Thor Motor Coach Technical Service Bulletin

TSB #	TSB 22-11		
Description/Title:	2022-2023 Sequence & Tellaro with Relion batteries		
Affected Product Line(s):	Certain model year 2022-2023 Sequence & Tellaro		
Service Campaign # :	RC000278	Released Date:	
Codes:	Inspect Only: 0.2 TMCTS80276Y	Document Date:	8/22/2022
Time Allowed:	Inspect with Repair: 0.3 TMCTS80276W	Document Revision:

0505721 – DIGITAL TIMER MODULE, 2 MINUTE, WITH RE-TRIGGER FEATURE

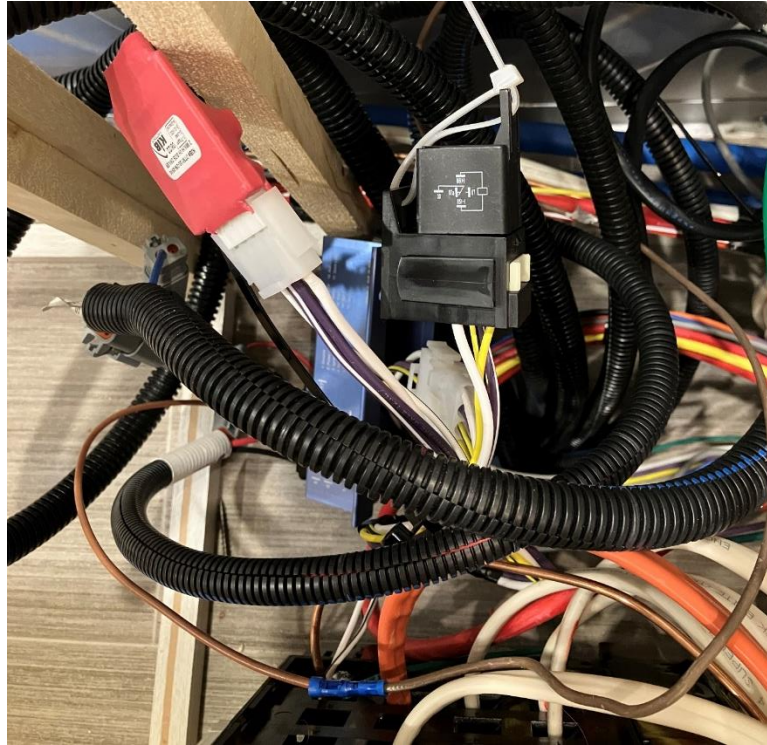
Timer module used with Relion batteries is not functioning properly which could overload the batteries and cause them to temporarily shut down. If the unit is not equipped with Relion batteries, no repair is needed.

2. Check date code on timer sticker.
 - a. Replace timer if dated prior to 8/22

3. Replace the timer if needed, timer connector is directional and will only connect one way.
